SUBJECT: REVIEW OF DRAFT STATUS SUMMARY REPORT FOR
NRR GENERIC TECHNICAL ACTIVITIES

SUBJECT: PROPOSED REVISIONS TO TASK ACTION PLAN A-39, "DETERMINATION OF SAFETY RELIEF VALVE (SRV) POOL DYNAMIC LOADS AND TEMPERATURE LIMITS FOR BWR CONTAINMENT"

TASK ACTION PLAN
TASK NUMBER A-39

Title: Determination of Safety Relief Valve (SRV) Pool Dynamic Loads
and Temperature Limits for BWR Containment

SRV PROGRAM SCHEDULE (Revision 1)

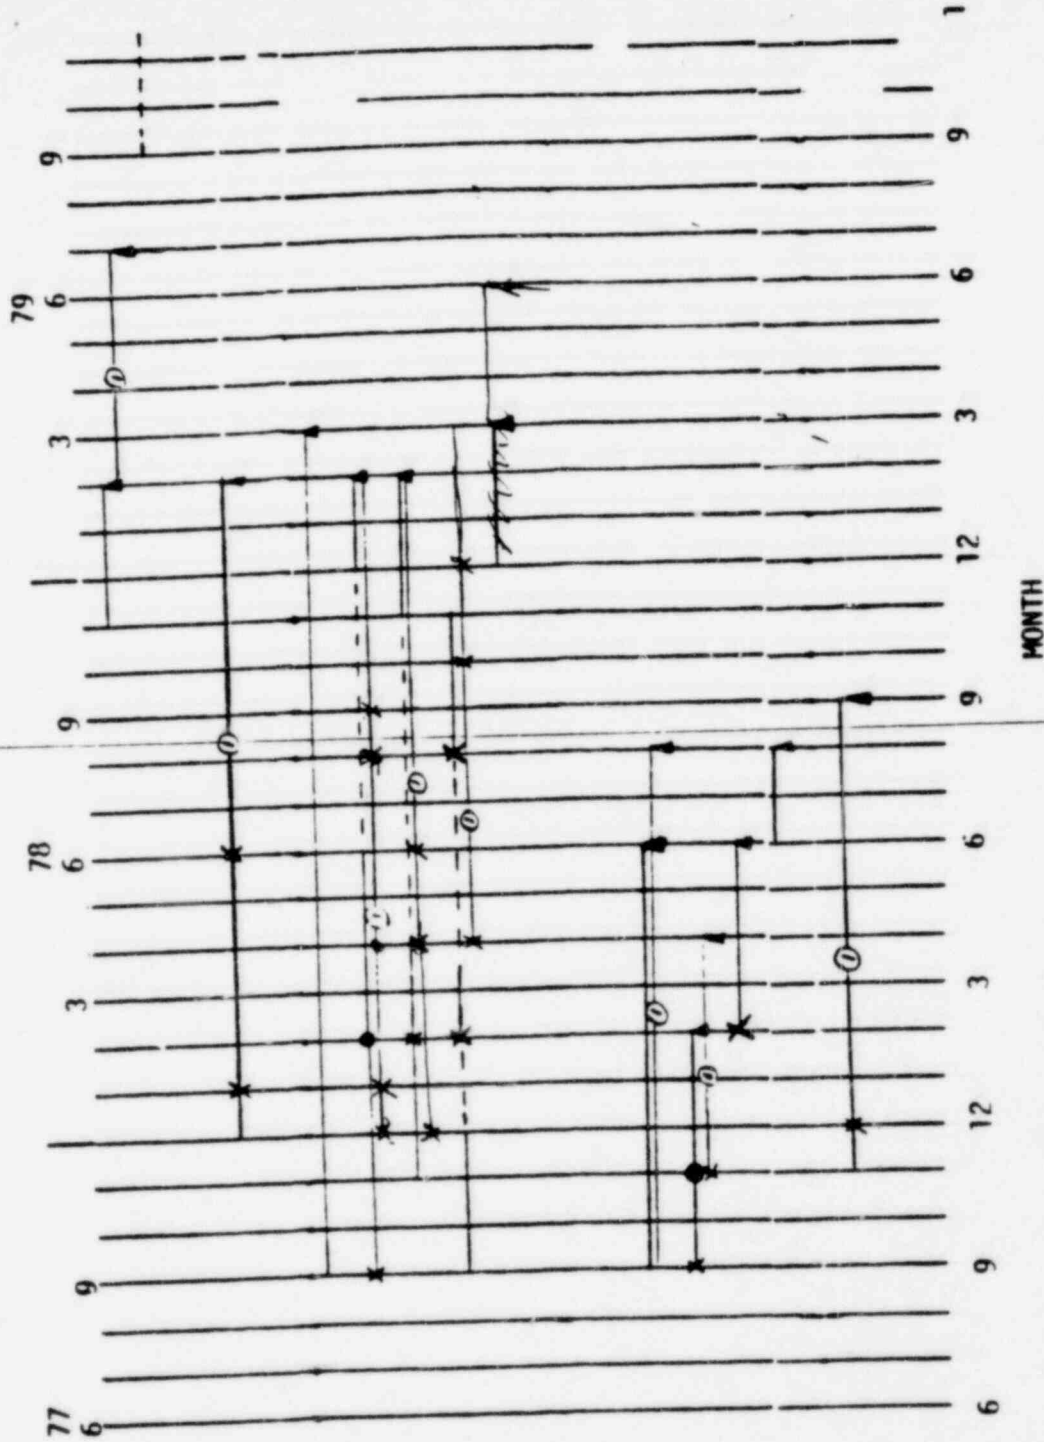
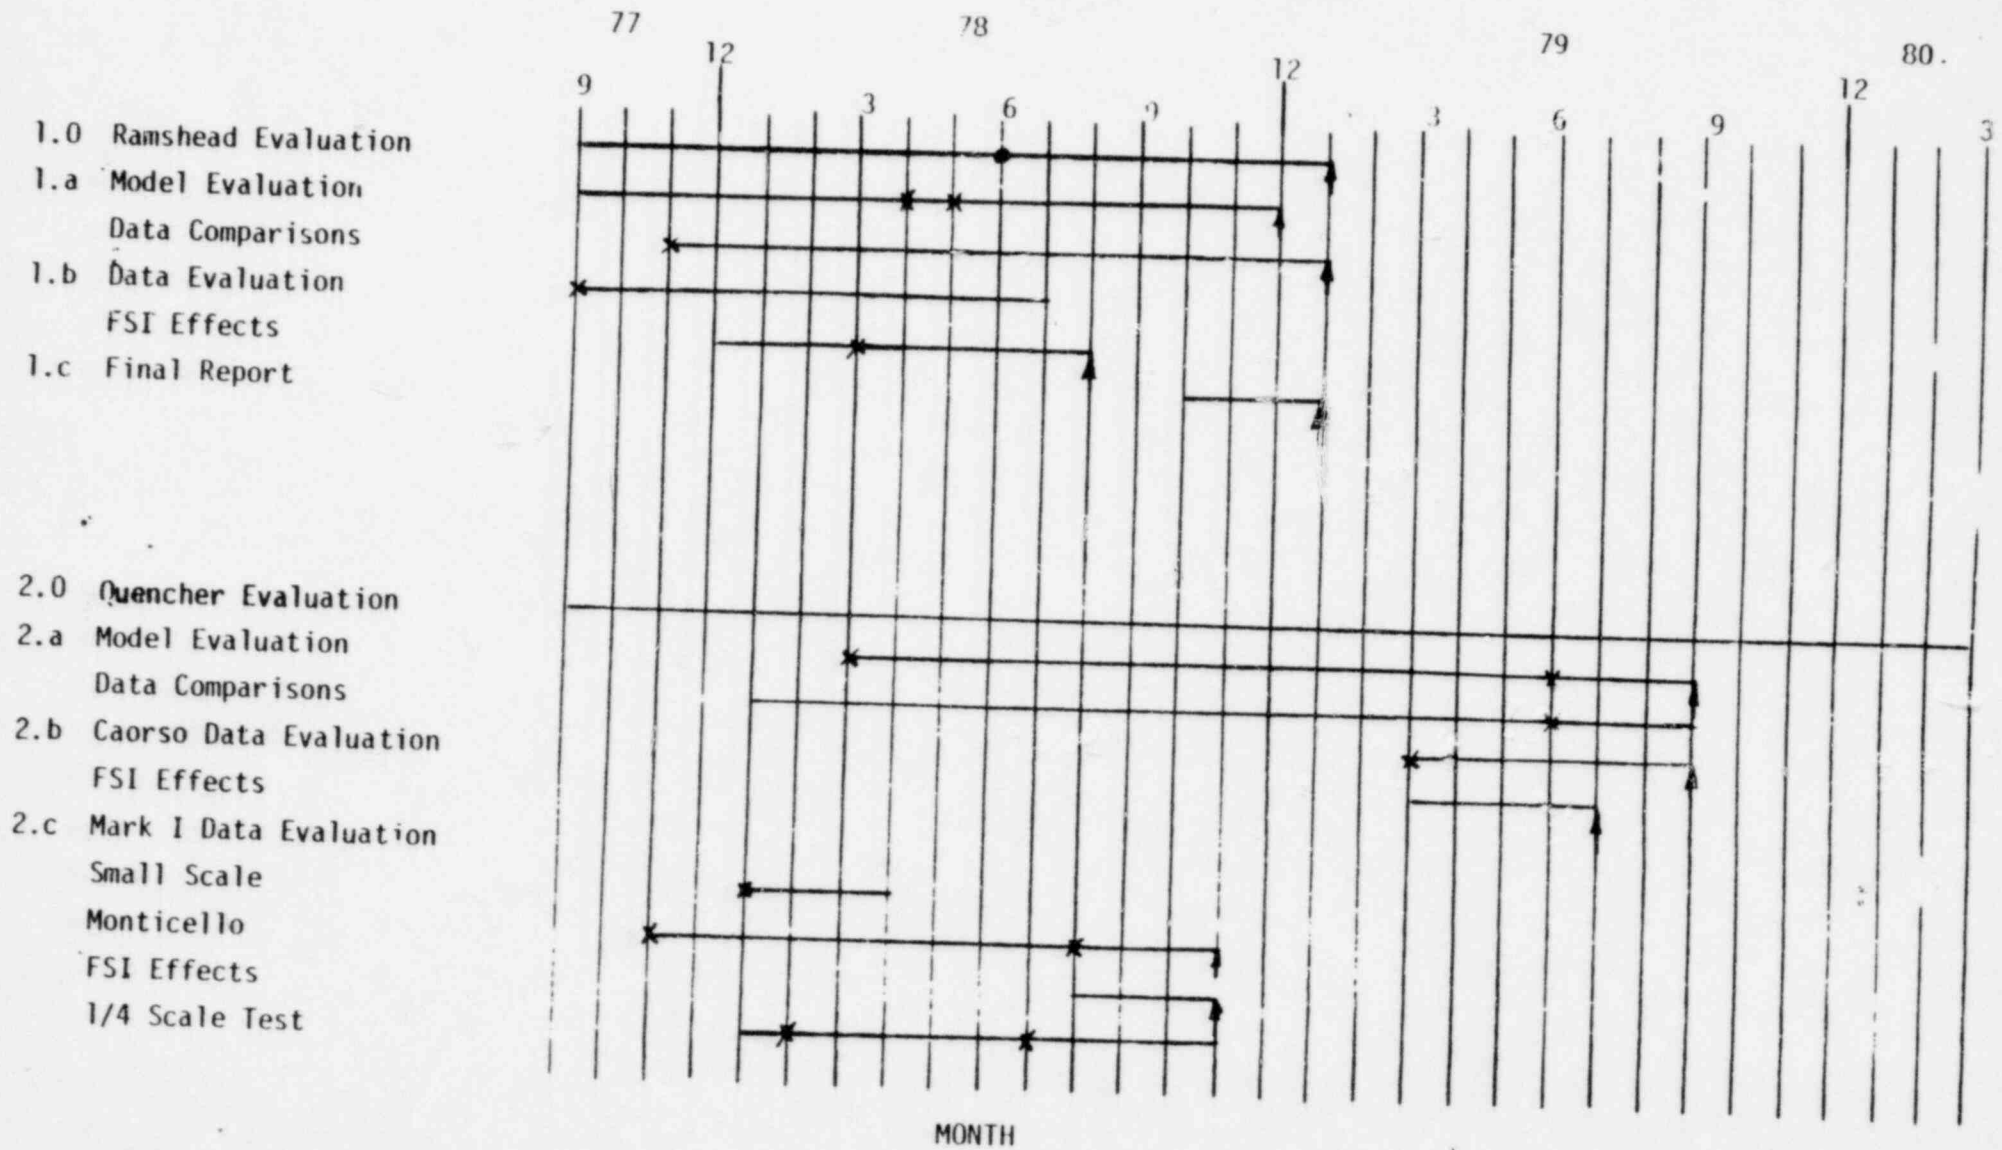
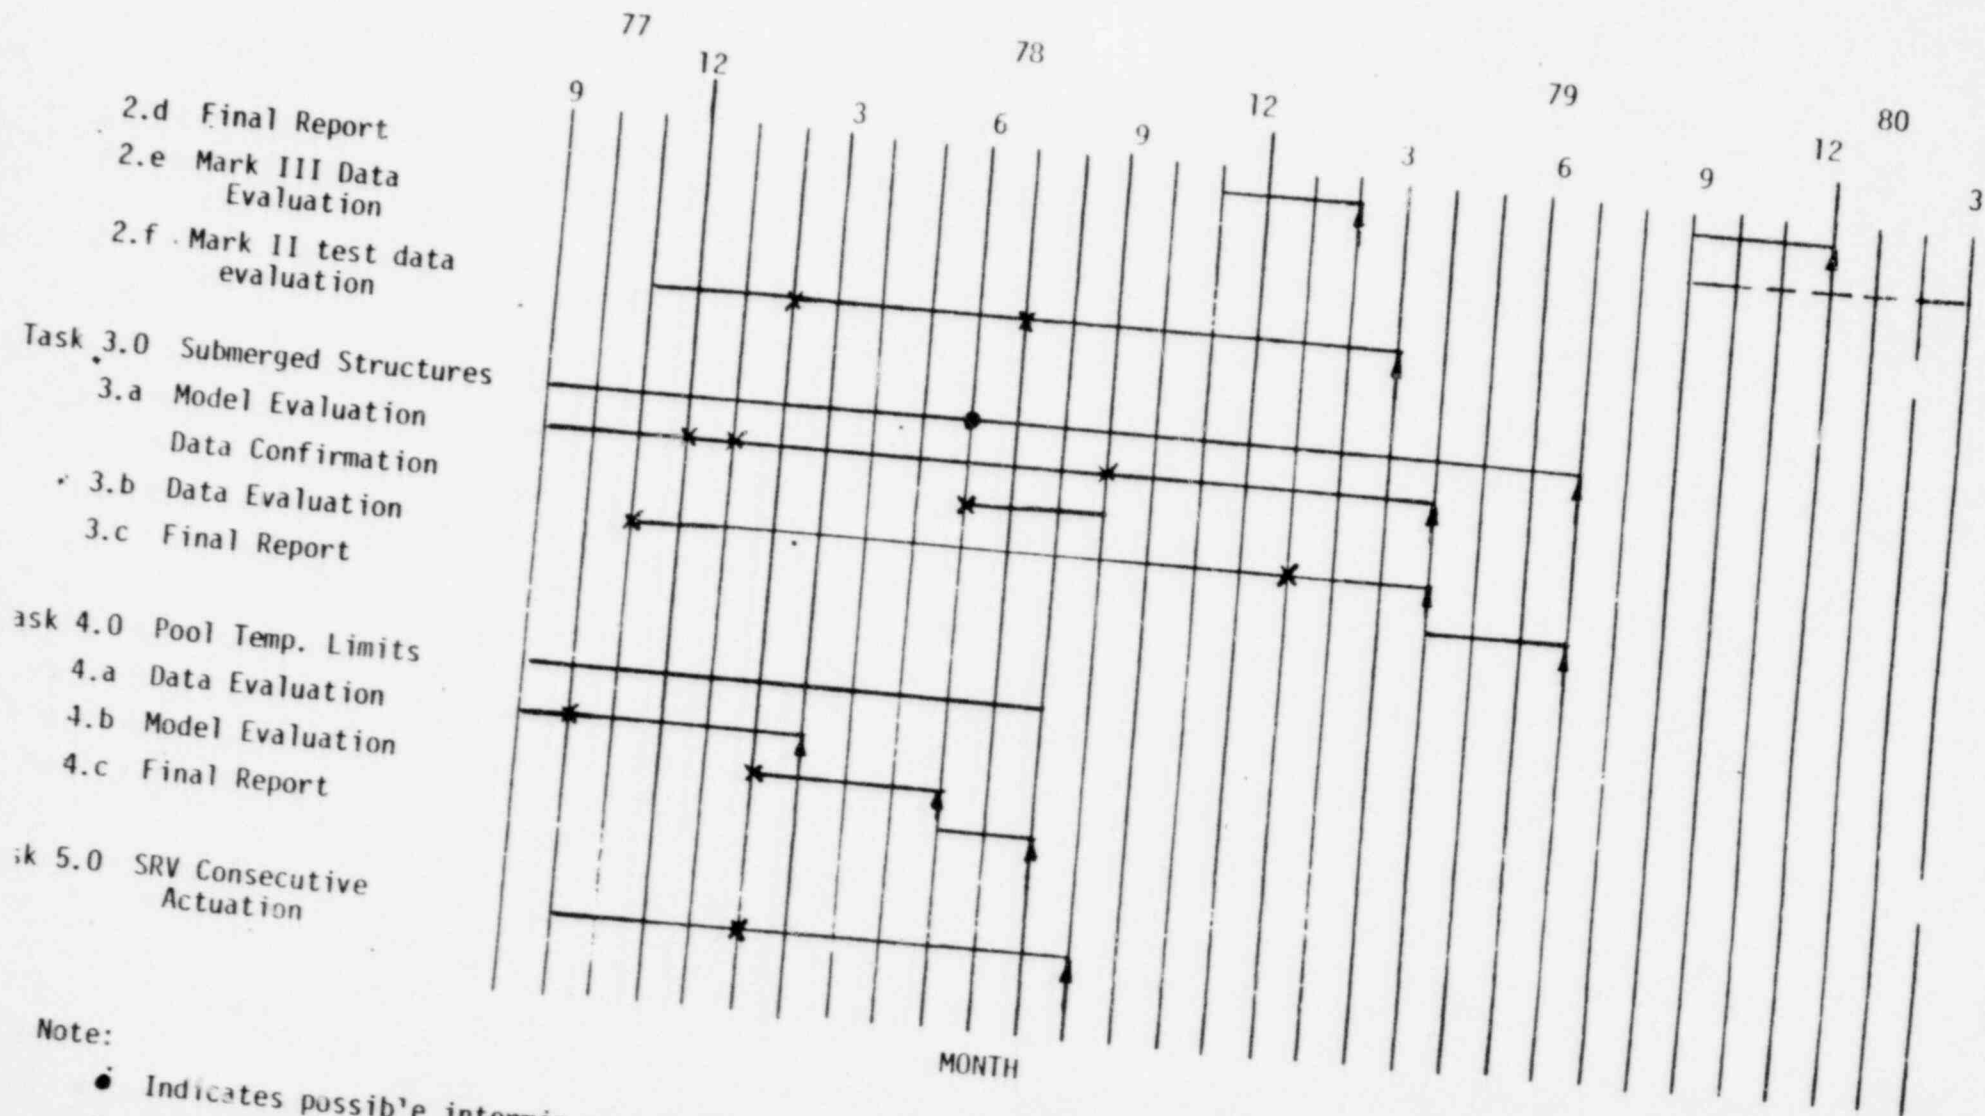
In light of this manpower unavailability we can anticipate the schedule to be slipped for several tasks. ^{Specifically, the ME's of RS's schedule related to the} ~~such as concerns~~ of Part 21 notification, ^{(2) response} ~~Mark I schedule~~ pool temperature limits and ^{(3) the response of the} SRV loads on piping and components. All of these tasks are closely related to the safety evaluation of licensing BWR plants. Unless adequate manpower is provided, we expect the schedule for plant applying operating license will be slipped from six months to one year. The lead OL plant is the Zimmer plant which has a projected fuel loading date of October, 1978.

①—Revised Schedule

1.1 Interim Ramshead Load Criteria	6/78	
1.2 Report of FSI Effects	8/78	
1.3 SER for Ramshead	11/78	
2.1 Report of FSI Effects	3/79	
2.2 SER for Quencher	7/79	(1)
3.1 Interim Submerged Structure Load Criteria	6/78	
3.2 Final Submerged Structure Load Criteria	6/79	
4.1 Reevaluation of Ramshead Pool Temperature Limits	4/78	
4.2 Final Criteria for Pool Temperature Limits	8/78	(1)
5.0 Report of SRV consecutive actuation	9/78	
6.0 Issue Revisions to Standard Review Plan	10/79
